Triton Knoll Offshore Wind Farm Limited Triton Knoll Electrical System

**The Applicant's Response to
Deadline 4**

**Document Ref: 2505-TKC-CON-
K-KX-0107**

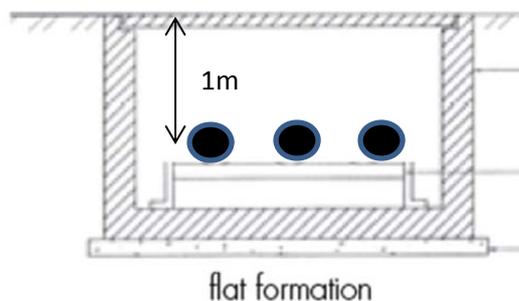
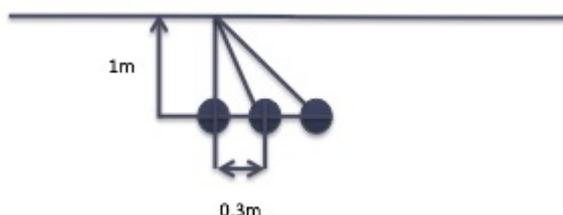
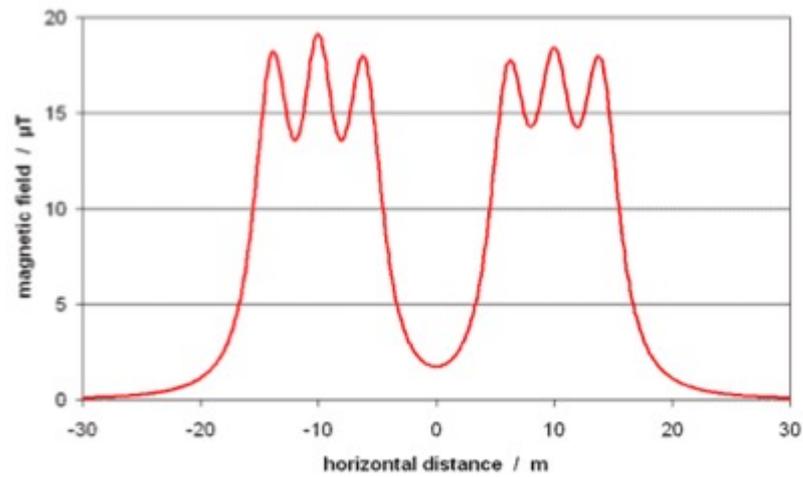
6. The electric field (V/m) is contained within the cable due to the earthed shielding around the cable; this is the case throughout the length of the cable, even at joints.

7. The magnetic field is a function of the current in the cable, and 1000 A has been assumed.

8. Below is a representation of one cable circuit in flat formation.

20. The magnetic field at the point 1 m directly above cable 1 (B_t) (i.e. at ground level) is given by:

$$B_t = B_1 + B_2 + B_3 = 200 - 96.15 + 166.54 j - 86.2 - 149.3 j = 17.65 + 17.24 j = 24.67 < 44.3^\circ$$
